Herefordshire Local Plan

Hereford Area Plan

Housing and Employment Site Options Consultation

Technical Site Assessments - Central Hereford

Cen08

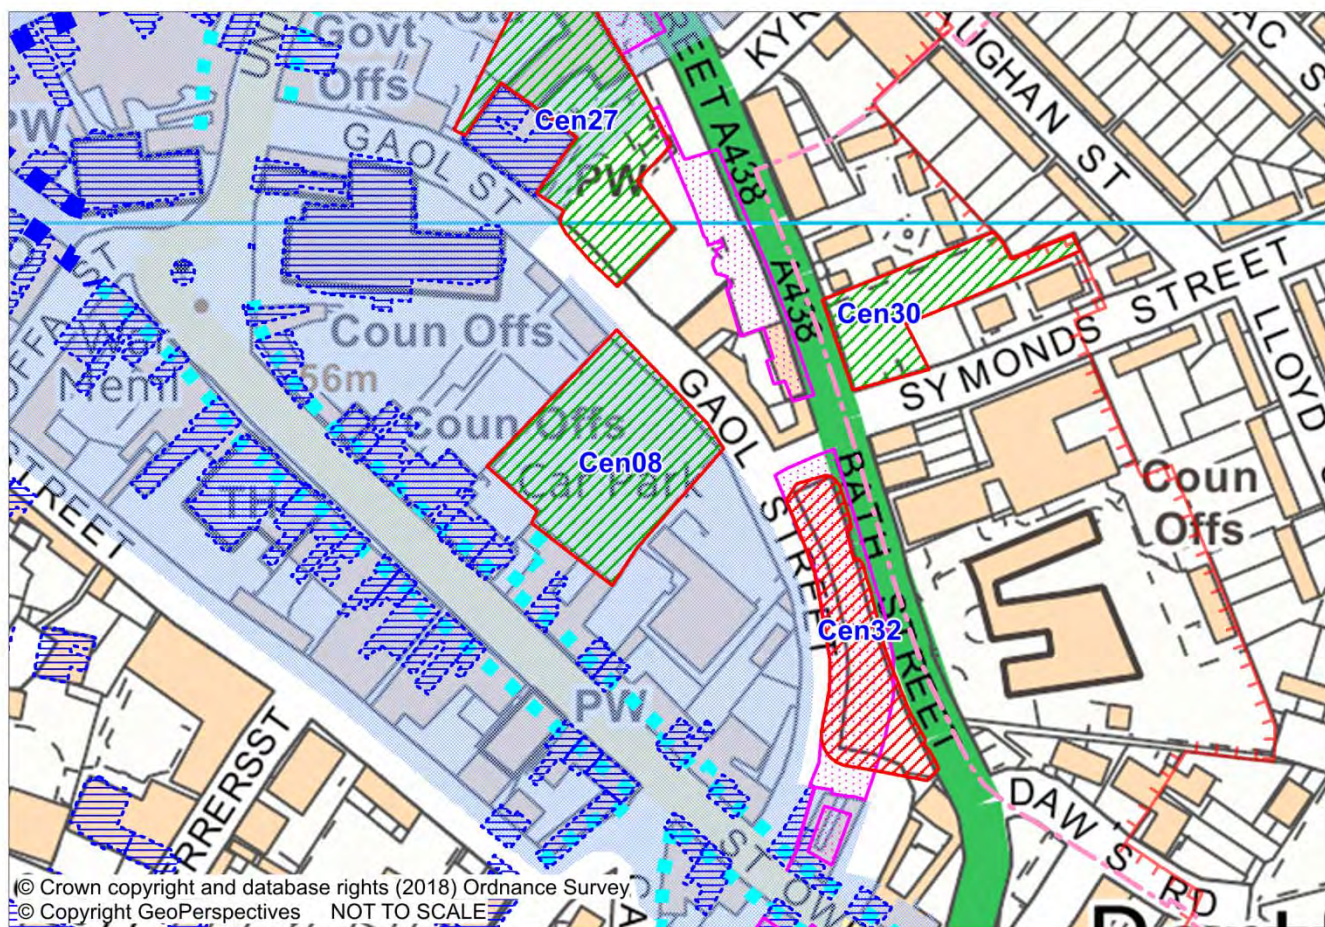
HC Highways comments
Public Transport accessibility comments
<i>Are standards for access to local services likely to be achievable?</i> Yes. City centre location. Pedestrian link to St Owens Street. Limited footway along Gaol Street would need improvement.
Access comments
Access could be provided to Gaol Street, as for the car park. A single point of access to a parking area to the rear or underneath would be preferred. Reduced car parking provision may be applicable, but that would be dependant on size and number of units proposed. Secure covered cycle storage should be provided.
Local network comments
<i>Any capacity concerns on this section of the network?</i> Bath Street/Commercial Road/Blueschool Street/Newmarket Street has capacity issues in peak hours and through late afternoon. A Transport Assessment would be required to assess the impact of the development on the network, and as with all HAP sites the scope and developments to be considered will need to be confirmed. Existing traffic generation of car park would be offset.

Site dependence on Hereford Transport Package
HTP may create more capacity on roads to the west, but possible downgrading of Blueschool Street may have implications.
Mitigation measures
Reduced car parking, cycle storage provision.
Highway site support
The car park (136 spaces) provides an important part of the overall car parking provision in Hereford city centre, being to the east of the centre and is well used. It also serves to provide car parking for the adjacent medical practices and dentists. The loss of car parking would need to be looked at overall with other sites and in conjunction with the council's car parking policy and review. Also residents with season tickets use the car parks overnight. If the loss of car parking was considered acceptable, then the site would be supported.

HC Conservation comments
Built conservation
Development possible – should respond to character of Conservation Area and setting of Listed Buildings, including views of Cathedral/All Saints/St Peters. Only high quality design which provides a positive contribution to the area would be permitted. The site offers the opportunity to help 'stitch' together part of the rather toothy nature of Herefords Townscape. With any major development proposals within the City, early engagement with the Council's planning and conservation teams is recommend, even prior to choosing an architect. The use of a design review panel would be a requirement of any project on the site. The site is situated within the Hereford Conservation Area – as such there is a statutorily desirable object for

Challenging, but possible. May be suitable for a well-designed development with a high degree of public benefit, but not otherwise. Rigorous prior assessment and evaluation needed. This comparatively large site [for a central location] is at the heart of the designated AAI, and is in close proximity to a number of nationally important heritage assets. Particularly in this respect the city wall, the shire hall, St Peter's church, and the town hall. Also, given the location, there is the potential for extensive, significant, and at risk below ground archaeology.

It would be essential in this location to base any proposals on the results of a detailed archaeological assessment and evaluation (NPPF Para 128), and a thorough process of pre-application discussions and design review.

Whilst the car park cannot be said to benefit the character and appearance of the conservation area, it does allow for views across the site to a number of Hereford landmarks e.g. the Cathedral tower, Shire Hall, Town Hall and the spires of All Saints and St. Peters. The archaeological sensitivity is remarked upon already.

Archaeologically sensitive area, has the potential for direct impacts on archaeological remains as well as the setting of Hereford city walls, ramparts and ditch SAM (UID: 1005528). Entire site is within the 'Hereford Area of Archaeological Importance'. Should be considered in heritage assessment.

To the rear of the site is the Grade II* Shire Hall former assembly rooms. There are many listed buildings in this area, and sensitive views of the Cathedral and spires of other listed churches. The site is in the conservation area and the curve of Gaol Street reflects the line of the city wall, the below ground remains of which are scheduled. The site occupies an area historically developed as burgage plots and gardens to the rear of the St Owen's street frontage. There is scope for sensitive development to enhance the character of the conservation area.

A city centre site with a mix of residential, commercial and health centre next door. Any proposal for the site should respond to the character of Conservation Area and setting of Listed Buildings, including views of Cathedral/All Saints/St Peters. Only high quality design which provides a positive contribution to the area would be possible.

The site has major historic matters which will need addressing if the site should come forward. Nevertheless the technical views do not discourage a scheme from coming forward. A bespoke approach is however necessary to focus on the local historic references. Archaeological assessment and evaluation will be necessary. If the challenges that come with the site can be overcome the site does have potential to deliver development. At a density rate of 70 dwellings per hectare, this site could deliver 25 units.

Cen21

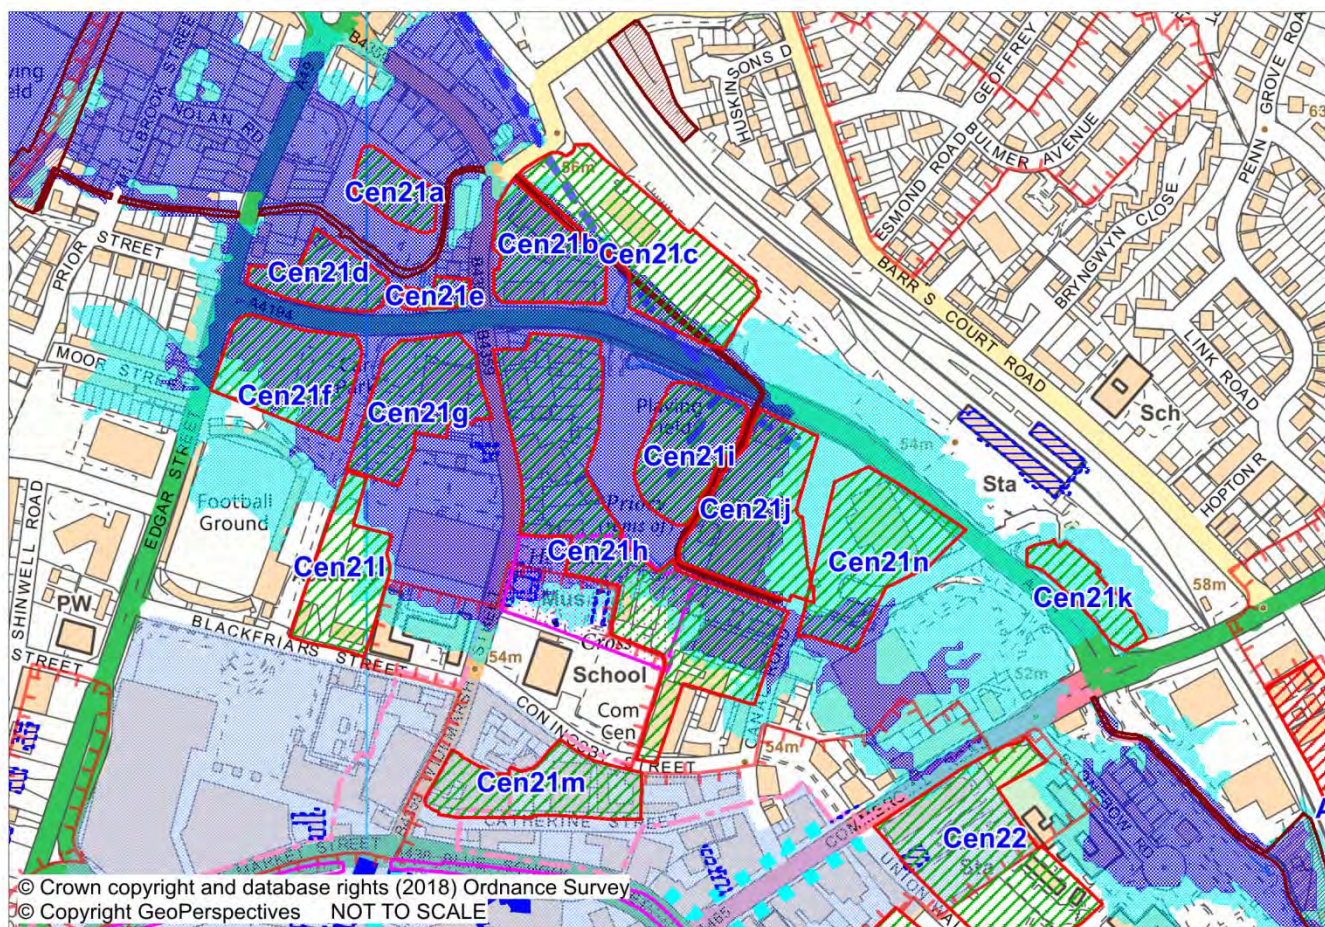
HC Highways comments
Public Transport accessibility comments
<i>Are standards for access to local services likely to be achievable?</i> Yes good connectivity and access to transport modes. Close to city centre Cycleway along link road.
Access comments
Access to various development areas adjacent to the link road were provided from the link road at the time of construction. Other plots will need to be assessed individually at the time they come forward.
Local network comments
<i>Any capacity concerns on this section of the network?</i> Not on the link road itself, but on Commercial Road and A49 Edgar Street. An initial estimate of traffic generation for the various plots was included in the Transport Assessment for the link road itself (CE092576/F).
Site dependence on Hereford Transport Package
An update to the link road TA or new VISSIM traffic model (when available) is necessary to update the traffic generation and background traffic. HTP may increase network capacity along A49 corridor.

Mitigation measures
May not be any mitigation necessary. Dependant upon impact.
Highway site support
Reduced car parking provision may be appropriate for some of the sites. Secure covered cycle parking should be provided. Cen 21b could have access onto Widemarsh Street as at present but would need to avoid central island.

HC Conservation comments
Built conservation
Whilst there is no statutory protection of the setting of Conservation Areas, there is precedent which allows the setting to be protected. Those sites outside the Conservation Area would need to consider the impact upon the setting of the Conservation Area. For those sites within the Conservation Area boundary, the statutorily desirable object of preserving and enhancing the character of the conservation area would be a key planning consideration. Any demolitions would be considered under s.138 of the NPPF (which refers to either s.133 or 134, either substantial or less than substantial harm). The setting of listed buildings within the centre of the city would need to be considered, in particular All Saints, St Peters and the Cathedral. Area Cen21f would be a key area where views would potentially be a design constraint. In terms of the Conservation Area and the Blackfriars/Coningsby Hospital sites especially, improving North South permeability would be key requirement of any development. This would enable the beneficial use of the Blackfriars site and better functionality of the townscape in the Coningsby/Catherine Street area. The canal corridor should be considered in terms of Cen 21c. For sites Cen21N & Cen21K the setting of the grade 2 Railway Station would be a key consideration as well as the setting of the Aylestone Hill Conservation Area.

Generally suitable, although some limited locations may be constrained. This 'ESG' area has been the subject of numerous very detailed studies over the last decade or so, and the typically *moderate* historic environment issues here are very well understood. Therefore, there is in my view no need for any further (desk based) assessments. In general, there is also no general need for any further field evaluations, except where relating to Blackfriars SAM.

This SAM (i.e. the remains and associated precinct of Blackfriars medieval friary and Coningsby hospital) forms the central hub of the ESG area. It is at once a constraint and an opportunity. Clearly, the scheduled parts of this nationally important heritage asset, and to some extent its immediate environs, are very problematic for development. Historic England will need to be consulted promptly and in detail in regard to proposals here.

Archaeologically sensitive area has the potential for direct impacts on designated and undesignated archaeology as well as setting impacts. Some of site falls within 'Hereford Area of Archaeological Importance' (https://www.herefordshire.gov.uk/downloads/file/1437/hereford_area_of_archaeological_importance_mappdf) as designated under 1979 Act. Blackfriars Friary, preaching cross and cemetery, and hospital and chapel of St John in Hereford SAM (UID: 1010797) is at the centre of this area.

The site is adjacent to the Conservation Area and could have a substantial impact on its setting and has a number of listed buildings that could be affected. There are opportunities for enhancement.

Conclusion			
<p>ESG is a large tract of land in the city centre covering approximately 11 hectares. The site is identified in the Core Strategy Policy HD2 as an area for regeneration of mixed use developments capable of accommodating 800 dwellings.</p> <p>The area is at a high risk of flooding and further work is being carried out to understand what the issues are as well as what mitigation measures could be used. The canal route also needs to be considered in any plans for the area. There is a Conservation area, Area of Archaeological Importance (AAI), Scheduled Ancient Monument in the Blackfriars/ Coningsby Hospital in the Cen21h and nearby area. There are also some listed buildings in the general area such as the railway station and Coningsby Hospital as well as the wider city centre buildings of All Saints, St Peters and the Cathedral area. Whilst some of these heritage assets are within the area identified for growth, the assets in the wider area which may be impacted upon will also need to be taken into consideration.</p> <p>The opening of the link road in December 2017, has released opportunities for growth in this area. NIMTE (the University) is considering parts of the area for potential faculty buildings and student accommodation. There is also the application for the blue light services to relocate here, therefore there will be a mixture of uses across the site so it will not solely deliver housing. The sites here have capacity to accommodate some, but not all of the 800 dwellings and estimates for housing capacity are approximate.</p>

Cen22

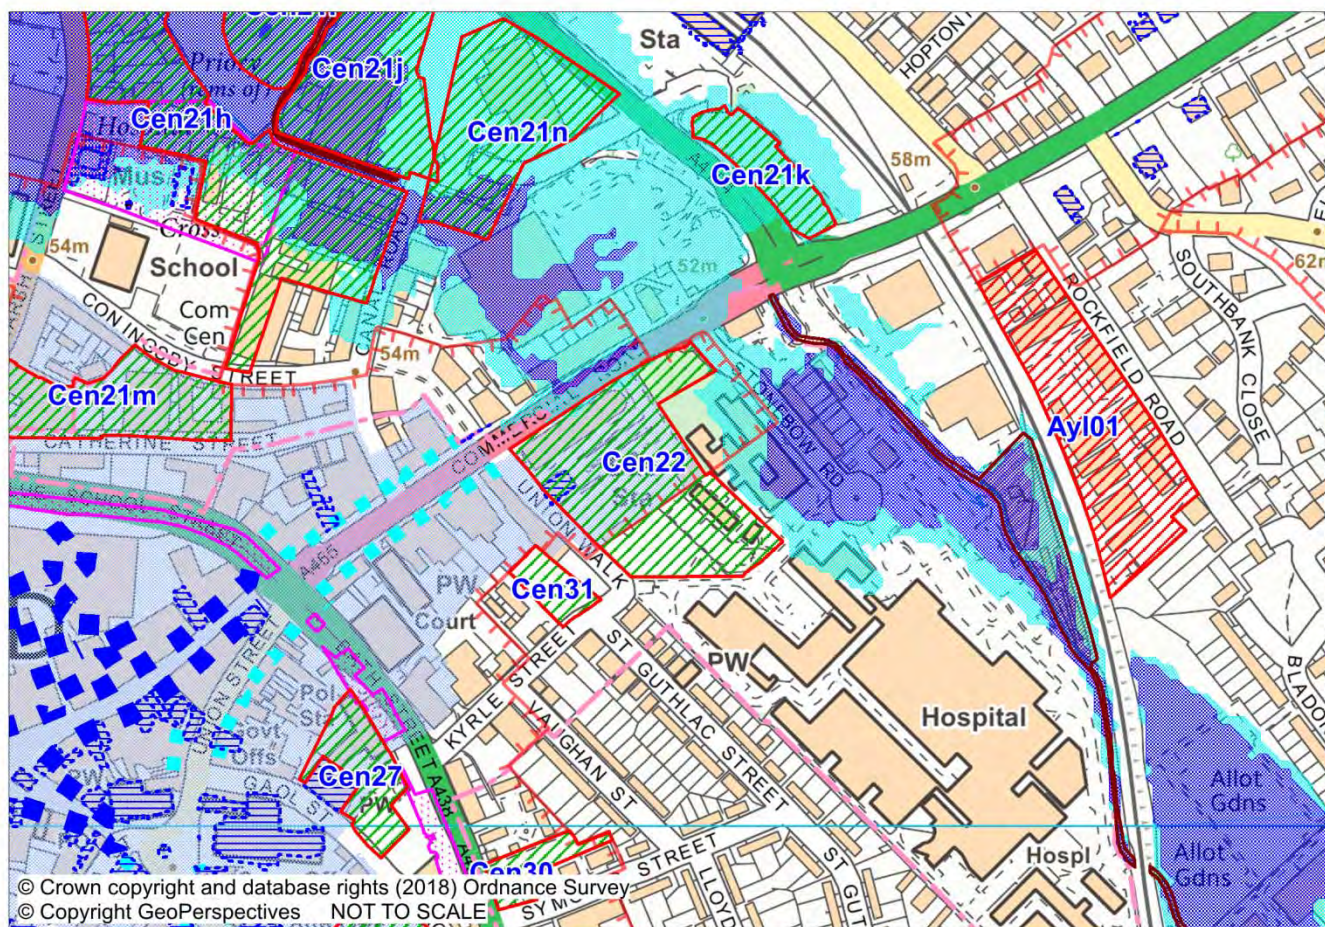
HC Highways comments
Public Transport accessibility comments
<i>Are standards for access to local services likely to be achievable?</i> Yes. Good connectivity to Commercial Road, bus and train stations.
Access comments
Access would need to be broadly as currently exists with a one way in from Commercial Road and out via Union Walk. Possible secondary access in from Union Walk as at present but dependent upon layout.
Local network comments
<i>Any capacity concerns on this section of the network?</i> The network impact may need to be covered in a Transport Assessment/Statement comparing vehicle movements and as with all HAP sites the scope and developments to be considered will need to be confirmed.
Site dependence on Hereford Transport Package
Yes. Dependent upon moving the bus station to the proposed transport hub at train station. HTP may create additional capacity on the network. Transport Assessment would be required to assess impact of the development.

Mitigation measures
HTP. Reduced parking provision may be appropriate in this location, depending on size and numbers of units. Secure covered cycle storage should be provided.
Highway site support
The car park provides an important part of the overall car parking provision in Hereford, being to the east of the city centre and is very well used. It also serves to provide overflow car parking for the hospital. The loss of car parking would need to be looked at overall with other sites and in conjunction with the council's car parking policy review. Also residents with season tickets can use the car parks overnight. If the loss of car parking was considered acceptable, then site would be supported.

HC Conservation comments
Built conservation
The site is situated within the Hereford Conservation Area on the site of the former Hereford Gaol, of which the Governor's house remains and is a listed building. In terms of development on the site there should be consideration of the history of the site, the street frontage to Union Walk and Commercial Road, the setting of the Listed Building and relationship to the area fronting Commercial Road. The height, design and massing of any buildings should respond positively to both immediate and wider context due to the site's position within a Conservation Area. NPPF policy 138 may apply with regards demolition of buildings in the conservation area and any proposals for new buildings should seek to enhance the character and appearance of the area.
Archaeology
May be suitable, but is likely to be challenging, and will need full prior assessment/evaluation. This site is within the designated Hereford Area of Archaeological Importance, and has links to a number of buried heritage assets of significance. The site may contain remains associated with the former county gaol here, and the lost medieval priory of St Guthlac. There are also other potential issues relating e.g. to the slight possibility of human remains being present, and the historical significance of the wall that forms the southern boundary to the site.

On the other hand, current research suggests that Priory remains of significance are perhaps unlikely to be within the site area itself and that the majority of the site will have been subject to an appreciable amount of comparatively recent disturbance, lessening its archaeological potential. Therefore, in summary, subject to acceptable assessment and field evaluation reports provided under NPPF Para 128, it may be that the site will be suitable from an archaeological point of view. If development does proceed here, potentially extensive archaeological recording or other measures may be required as mitigation.

Whilst mindful of the Conservation Area and other heritage constraints, redevelopment of the bus station and car park (subject of course to the necessary assessment by others of car parking strategy), redevelopment would be acceptable in principle.

Archaeologically sensitive area, has the potential for direct impacts on archaeological remains. Entire site is within the 'Hereford Area of Archaeological Importance'. Should be considered in heritage assessment to assess if development is appropriate/ sustainable.

This urban site has a variety of uses including the current bus station, car park, church, restaurant and part garden area of the hospital grounds. There is the former Governor's House which is a listed building within site. The majority of the site is situated in a conservation area. This site is also within the designated Hereford Area of Archaeological Importance, and has links to a number of buried heritage assets of significance. The surrounding land use is mainly hospital land. Other uses on adjoining roads are mixed including a service station, public house, takeaways, retail and residential.

This is a sensitive site in terms of archaeology and therefore field evaluation would be necessary. In terms of highways the site is acceptable if current one way access is retained but would be subject to a Transport Assessment. A replacement bus station would need to be identified if this site is lost.

If all of the above can be addressed and in particular the archaeology value, then the site could have potential to accommodate a sensitive development that responds to the historic nature of the area. There may be a restrictive covenant on the site and the same will need to be investigated.

Cen27

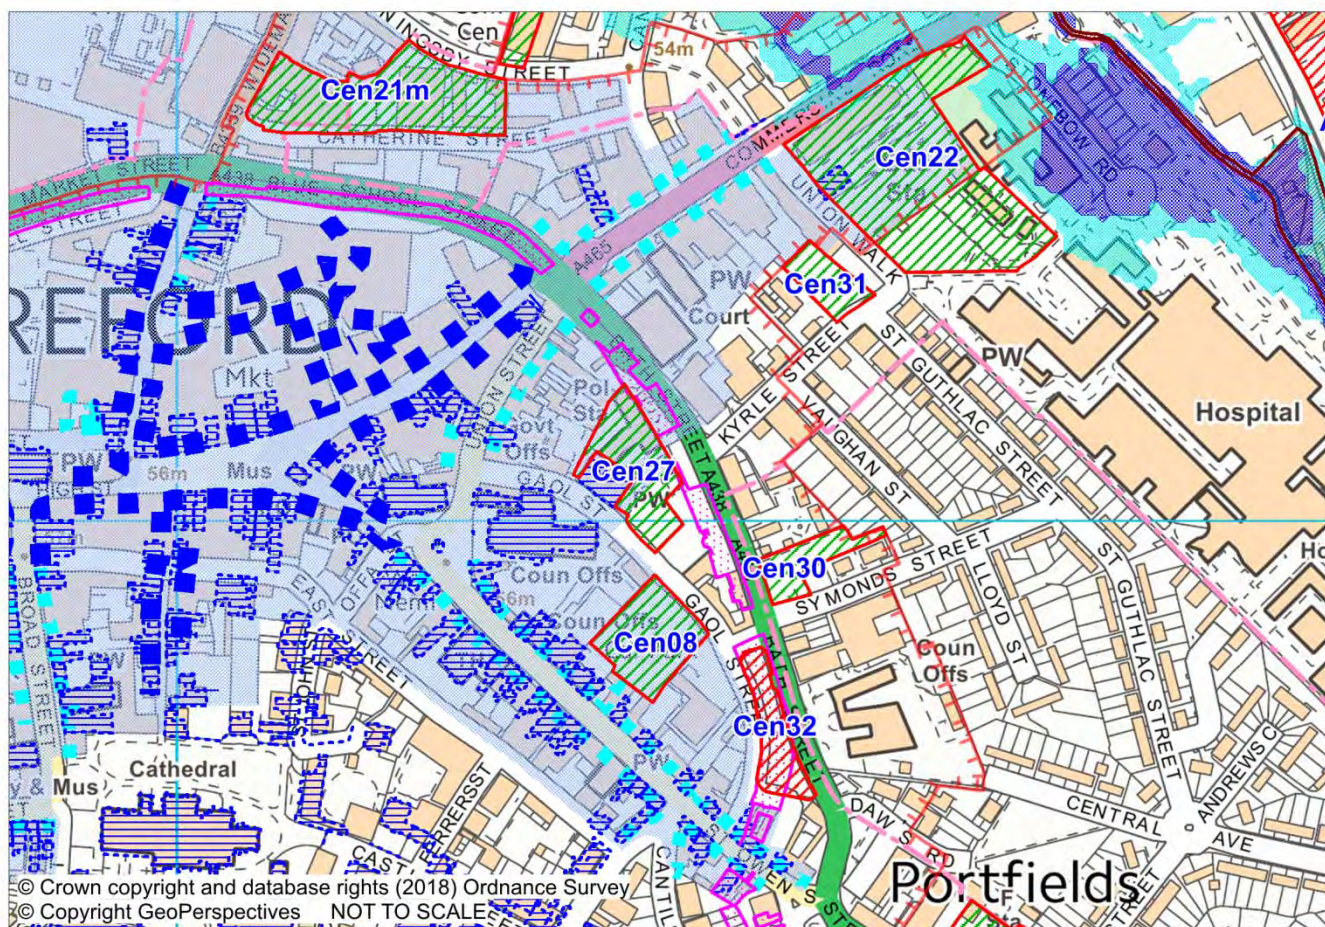
HC Highways comments
Public Transport accessibility comments
<i>Are standards for access to local services likely to be achievable?</i> Yes. City centre location, close to facilities, bus and train stations.
Access comments
Access would be achievable from Gaol Street as at present. Access to Bath Street not considered acceptable. Parking should be to suit Gaol Street access or underneath dwelling. Reduced parking provision may be appropriate subject to number and size of units. Secure covered cycle storage should be provided.
Local network comments
<i>Any capacity concerns on this section of the network?</i> Yes, Bath Street/Commercial Road/ Blueschool Street/Newmarket Street congested at peak hours and late afternoon. Current use would need to be offset in a Transport Assessment.
Site dependence on Hereford Transport Package
HTP may provide additional capacity on the network but possible downgrading of Blueschool Street may have implications.

Mitigation measures
Reduced parking provision. Cycle storage.
Highway site support
Provided network capacity exists, would support development of the site. Perhaps combine with Bastion Mews for which various attempts at development have been made but issues with such a confined site.

HC further comments
Built conservation
The site is situated within the Hereford Conservation Area. Development on the site is not precluded on matters related to built heritage however any proposal should preserve or enhance the character and appearance of the Conservation area. As the decision making body for SAM consent it is recommended that Historic England are consulted relating to the SAM to the north east of the site and that the Council's Planning Archaeologist is consulted with regards below ground archaeology. It is felt that the area of the ditch should not be developed in order to retain an understanding of the morphology of the site. The area of the wall and the ground to the SW of this would be supported for appropriate development.
Archaeology
Unlikely to be suitable, except through an agreed design solution of very high quality. This site (and more detail should be provided as to its <i>exact</i> boundaries) is an exceptionally sensitive site archaeologically. Fully within the designated Hereford Area of Archaeological Importance, it also directly abuts the nationally important city walls SAM. Depending on how the precise boundaries are drawn, and what a proposal might entail, the site might also be regarded as partly <i>within</i> the SAM. There would normally be a strong presumption against development here, and scheduled monument consent might additionally be required. However, it is noted that there are already a number of buildings of low merit already on site, buildings which might possibly be subject to appropriate refurbishment / replacement. No assumptions of acceptability should be

made, and it is emphasised that such refurbishment / replacement would need absolutely to a) to result in a commensurate or preferably lesser impact than the buildings currently there, b) provide substantial and demonstrable public benefits /enhancement, and c) be informed and mitigated by a full process of assessment, evaluation, design, and recording. This process in itself would be expensive, intrinsically so.

The existing building, whilst functional, does not contribute to either the character or appearance of the Conservation Area. If a suitable replacement site for the police station could be found, there would be a lot to commend conversion of the site in a manner that might better reveal the historic significance of the location.

This is the site of the existing Police Station which is seeking to relocate. The surrounding area is mixed uses, with a restaurant (A3), Listed church, Berrows Business Centre opposite and a private car park adjacent. It is a large building within the Central Conservation Area and immediately adjacent the City Walls SAM. The site is also within the Area of Archaeological Importance. It is an exceptionally sensitive site archaeologically. A very sensitively designed conversion may be more suitable than a redevelopment. No assumptions of acceptability should be made, and it is emphasised that such refurbishment / replacement would need absolutely to

- a) result in a commensurate or preferably lesser impact than the buildings currently there,
- b) provide substantial and demonstrable public benefits /enhancement, and
- c) be informed and mitigated by a full process of assessment, evaluation, design, and recording. This process in itself would be expensive.

Access to the site is recommended via Gaol Street. Subject to overcoming the above stipulations which could have a bearing on site viability then the site could be suitable.
